MFN 06-309

Docket No. 52-010

**Subject: Response to Portion of NRC Request for Additional Information  
Letter No. 54 Related to ESBWR Design Certification Application –  
Auxiliary Systems – RAI Numbers 9.1-1 through 9.1-26, and  
Amended Response to RAI Number 2.4-23 from NRC RAI Letter No.  
32**

**Response to Portion of NRC Request for  
Additional Information Letter No. 54  
Related to ESBWR Design Certification Application  
Chapter 9 - Auxiliary Systems  
RAI Numbers 9.1-1 through 9.1-26 and  
Amended Response to RAI Number 2.4-23  
from NRC RAI Letter No. 32**

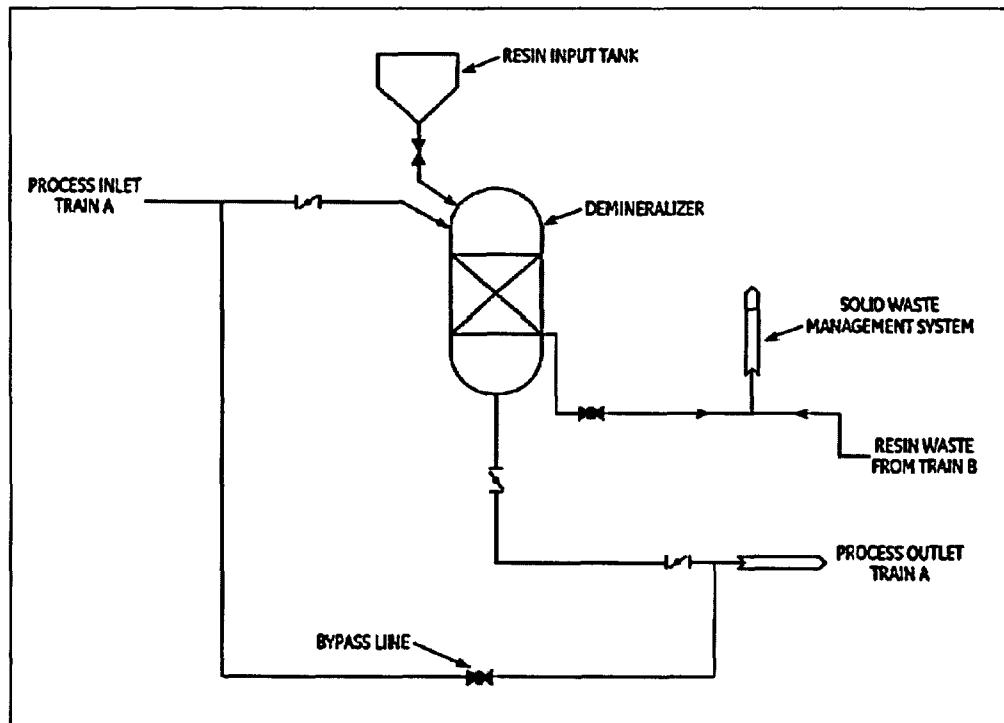
*DCD Tier 1, Figure 2.6.2-1 does not show any flow paths to reject excess water or radioactive waste (e.g., resin) to liquid and solid radioactive waste systems, respectively.*

*Describe how the FAPCS is used to manage pool water inventory and how waste from the water treatment subsystem is handled. Update DCD Tier 1, Figure 2.6.2-1 to show these capabilities.*

DCD Tier 1 Rev. 1, Figure 2.6.2-1 does indicate the capability to discharge water to the Liquid Waste Management System (abbreviated as LWS on figure) by way of the overboarding lines connected to valves F016 and F017.

The filter/demineralizer units are shown in an extremely simplified form, and do not include details such as a discharge path for the spent resin. The full P&ID includes a complete process flow path for the resin to be discharged to the Solid Waste Management System. A simplified drawing of the demineralizer units is included with this response to supplement the figure in the DCD.
